SERVICE LETTER

No. 648

Subject: Battery Ground Inspection and Modification

Models Affected: PA-24-260 "C" Comanche

Relocated Ground Attachment Detail

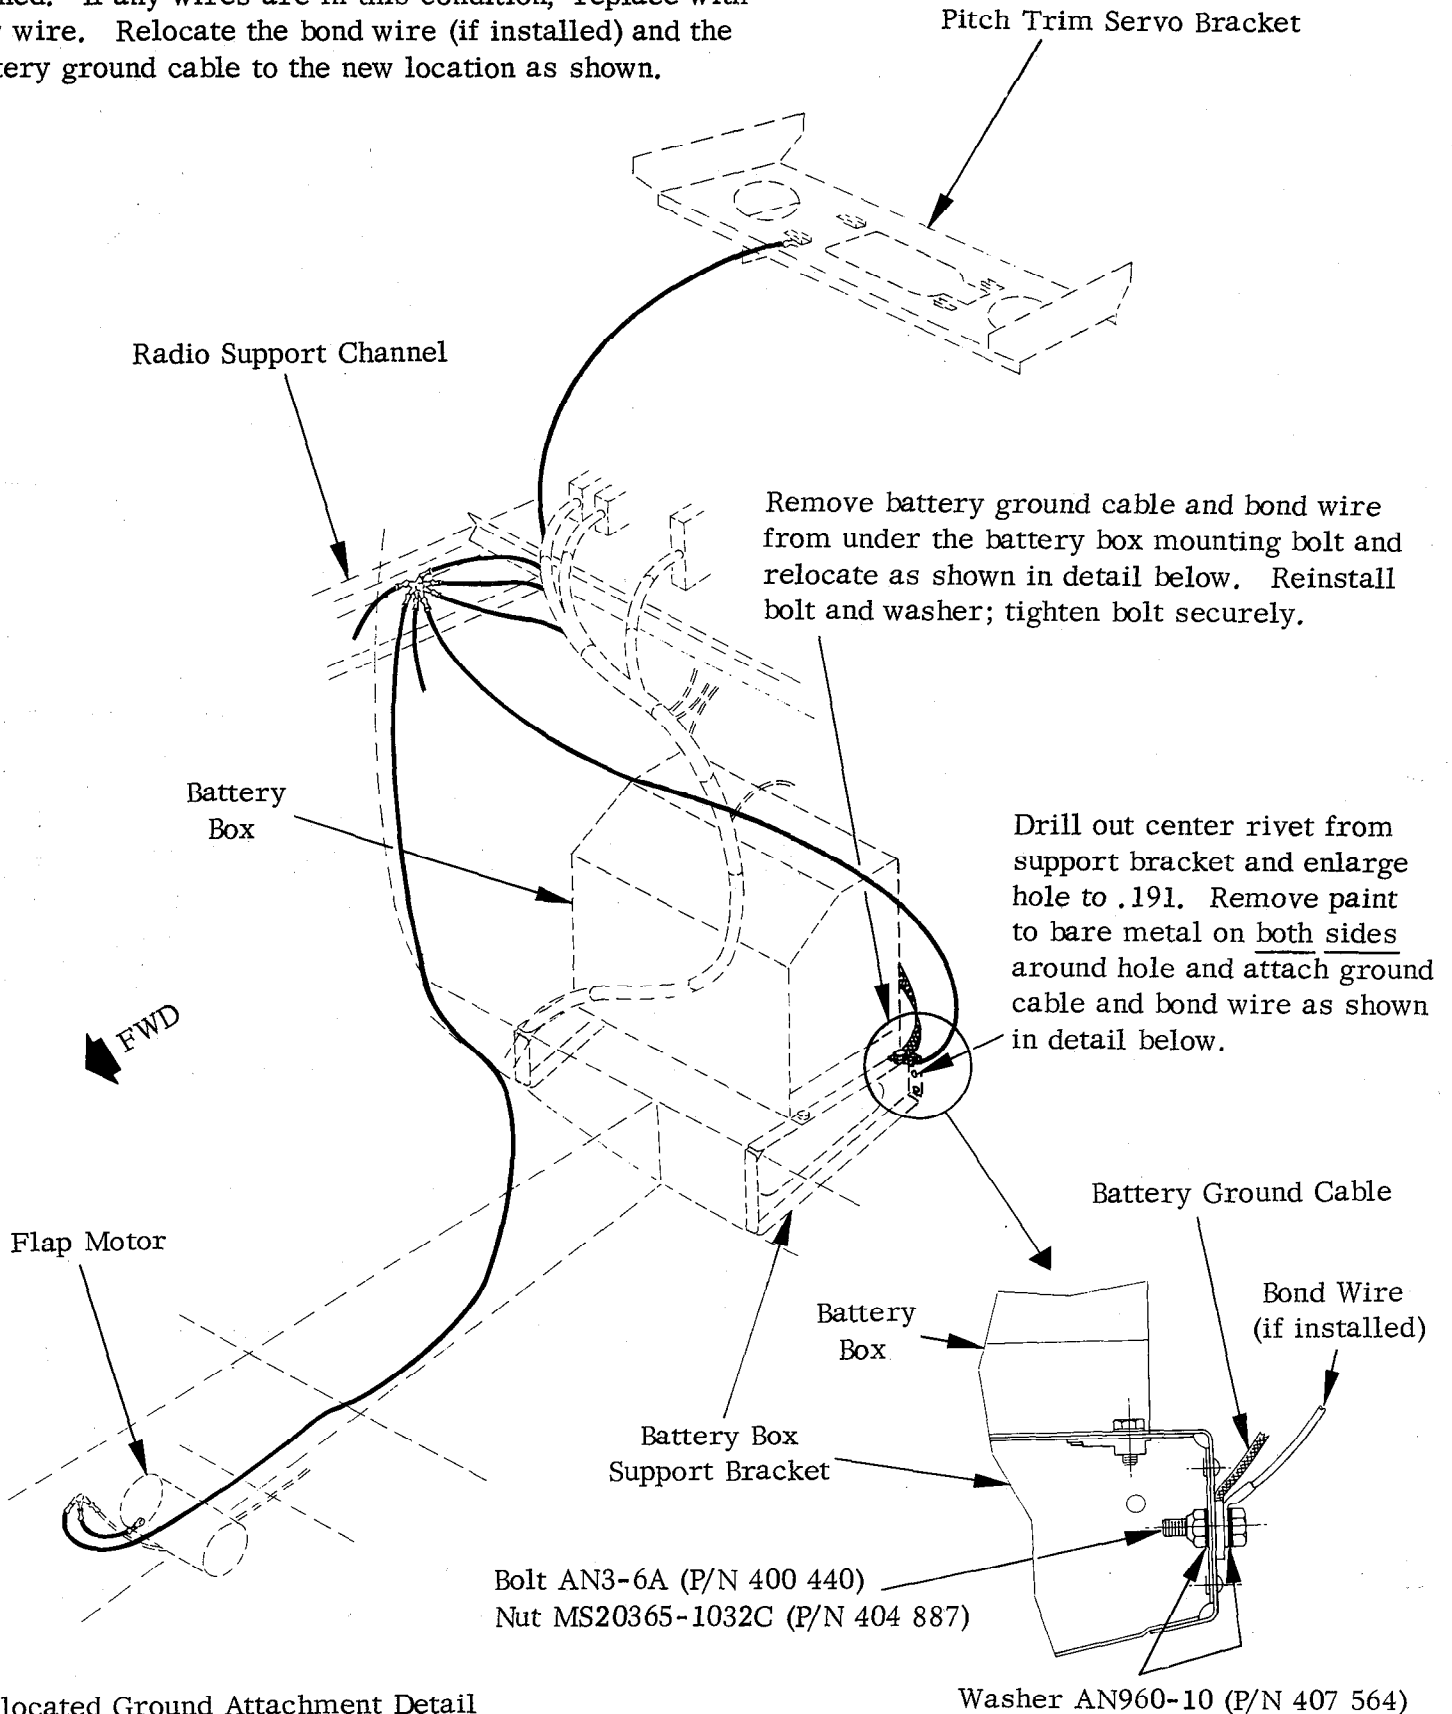
Purpose: A field report has been received describing damaged electrical wiring in the battery area -- in the form of scorched or burned wires. This condition was attributed to improper attachment security of the battery ground strap and bonding wire (if installed) to the battery box mounting bolt.

This service release provides instructions to inspect wires as shown in the sketch (on reverse side of this Letter) for indications of scorching or burning and to relocate the battery ground strap and bond wire (if installed) to a new location on the inboard battery box support bracket (refer to the sketch/instructions on the reverse side of this Letter).

Inspect all wires (indicated by solid lines) in the battery area for the possibility of any wires being scorched or burned. If any wires are in this condition, replace with new wire. Relocate the bond wire (if installed) and the battery ground cable to the new location as shown.
